TMY NEWS NO. 1308 "MICRO"

Notice of design change

MICRO No. MTW-5139F (T-5139F)

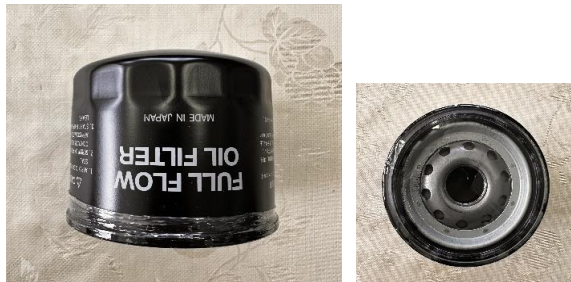
- a) Changed case body color from black to "ivory white"
- b) Changing the shape of the bottom oil hole
- c) Change in product height size

Current : 93 X 108 X 11/8-16 → Changed : 90 X 108 X 11/8-16
